Tullamarine Landfill

Community Consultation Group

MEETING NOTES

30 November, 2016

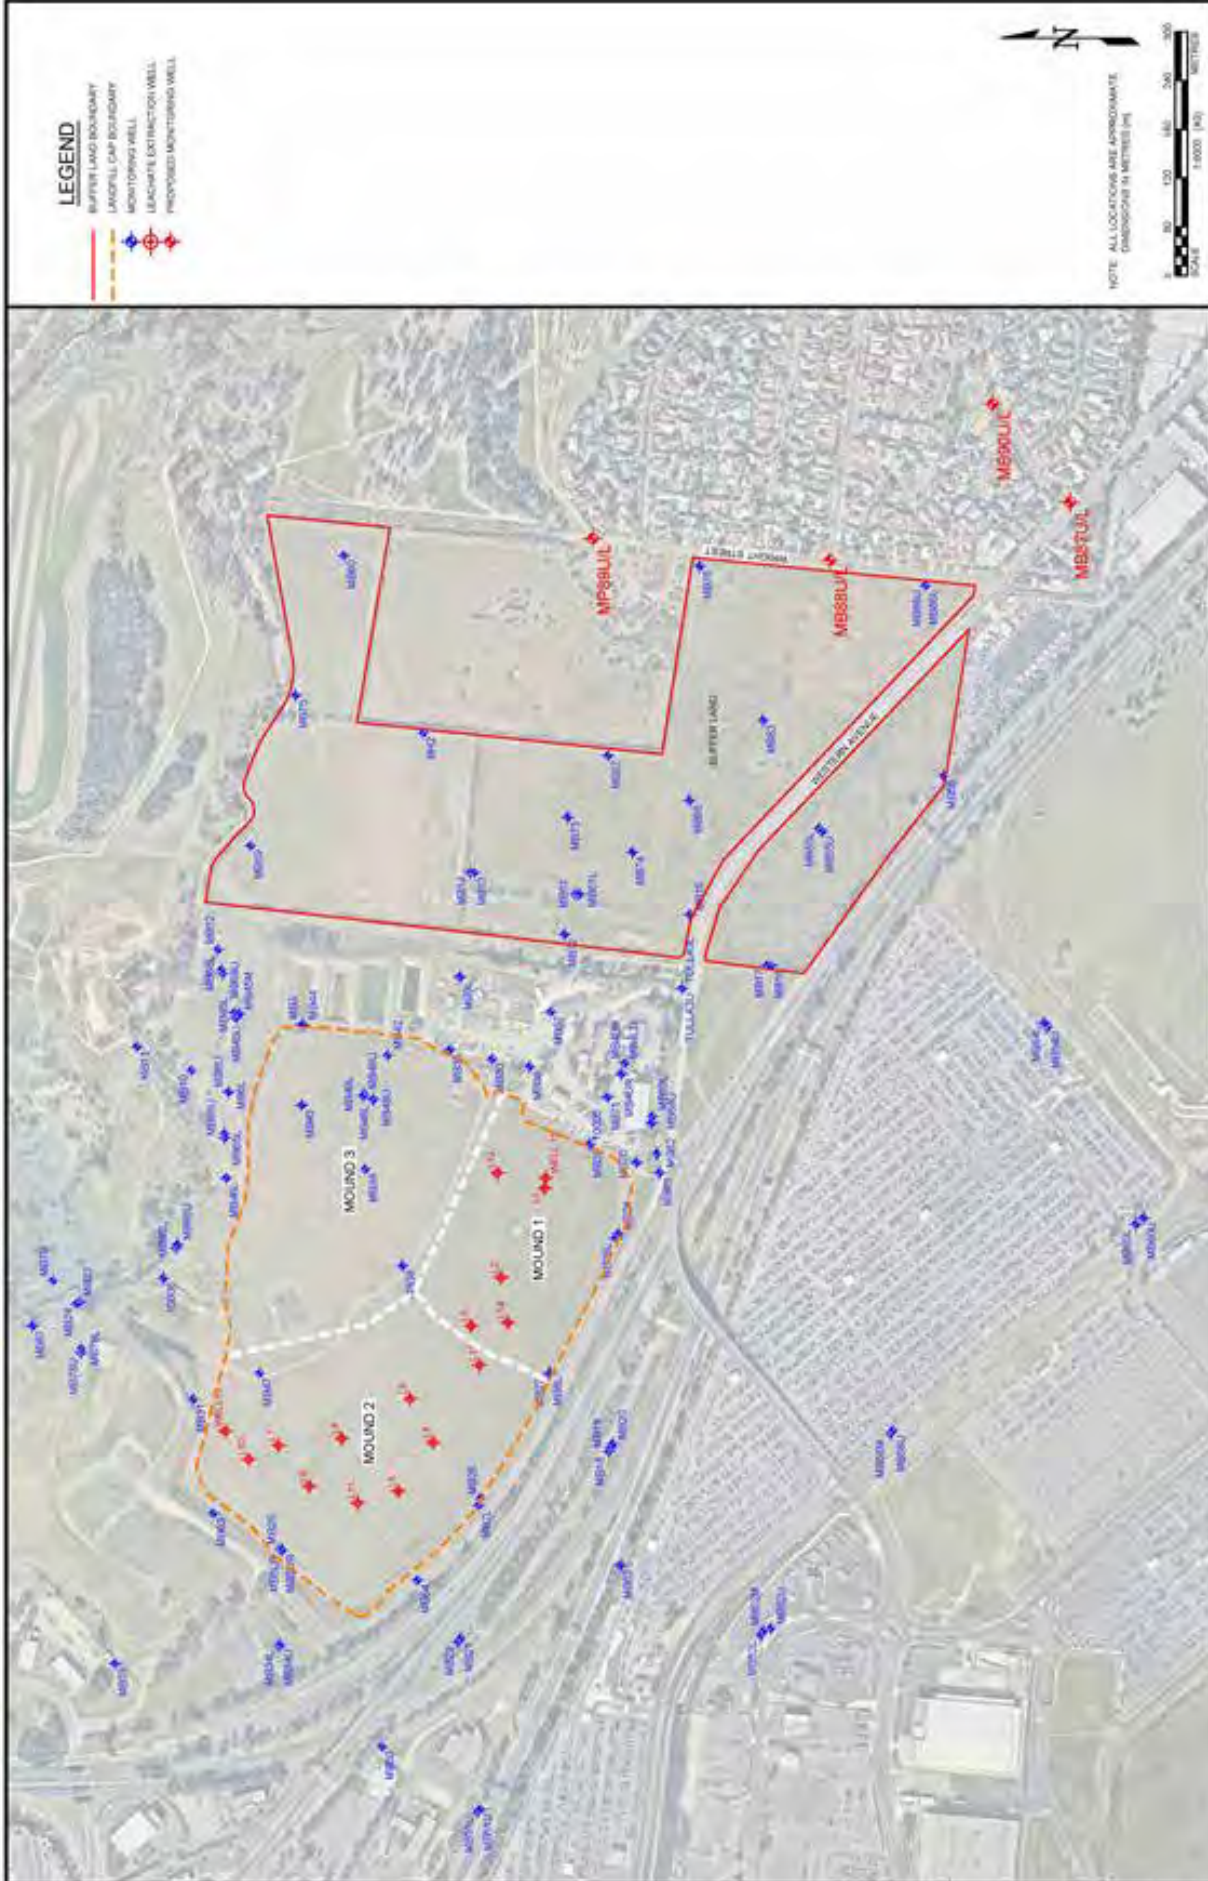
QUESTION: Is the LNAPL extracted being tested? If not, it would seem to be a wasted opportunity to get more information regarding the LNAPL.

ALAN: No, the LNAPL is a very small proportion of the total volume of leachate extracted. As both leachate and LNAPL are mixed together then the LNAPL cannot be tested. Sampling specifically for LNAPL would be required to obtain a representative sample.

KIEREN: LNAPL was tested discreetly in wells L14, L1, and L9 as part of the earlier LNAPL baildown trials and reports were made available at the time.

Figure 4 from Kleinfelder Report

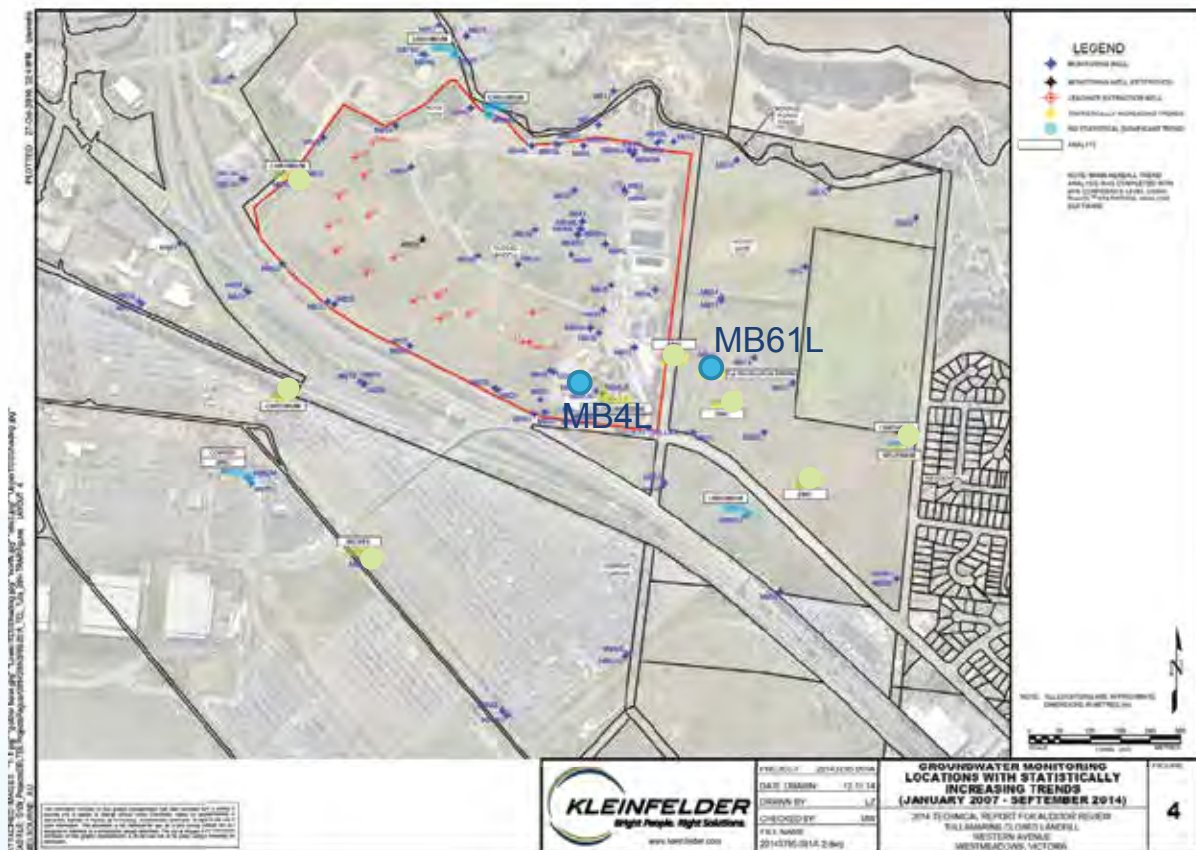
QUESTION: Are the metal level data results in the Groundwater report?

Figure 4 highlights the trend anomalies in the levels of metals and hydrocarbons. Yellow dots show an increasing metal trend and blue shows increasing hydrocarbon trends.

Conceptual Model – 2035

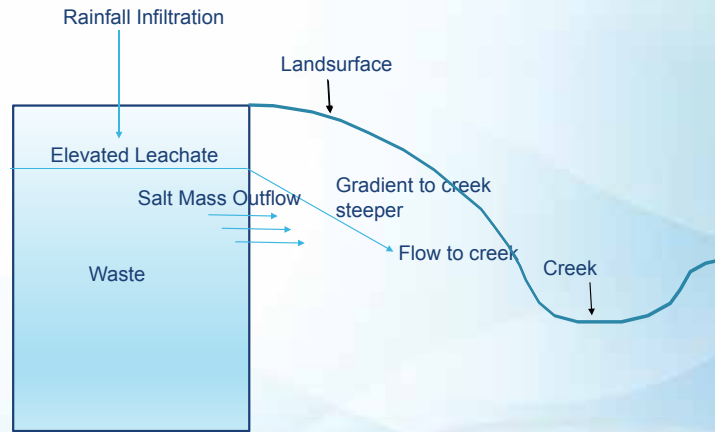
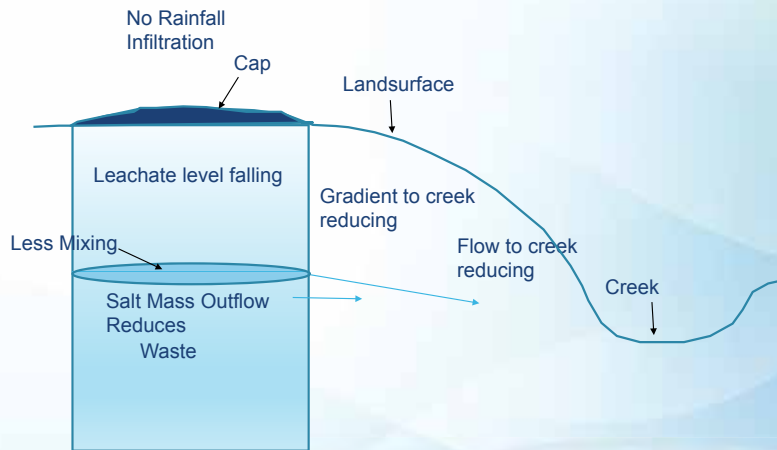
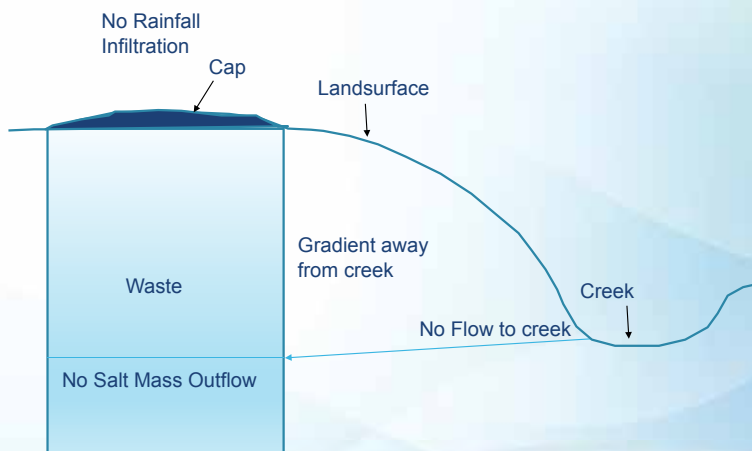
QUESTION: Where is the leachate? Is it in the groundwater heading offsite?

COMMENT: *The salt is still heading towards Steele Creek!*

COMMENT: *The 2035 conceptual model needs to be verified so we know where the leachate will go in the future and if it will affect other areas and communities. It assumes that in 2035 the salt will be below the level of the creek but there is no evidence that this will be the case.*

KIEREN: The Kleinfelder TRAR report Figure 11A shows what is happening to the salt (see below). The salt is heading towards the airport (away from the creek) in the water table aquifer. This correlates with what we are finding but it does not yet provide proof because levels in the landfill need to fall a bit further.
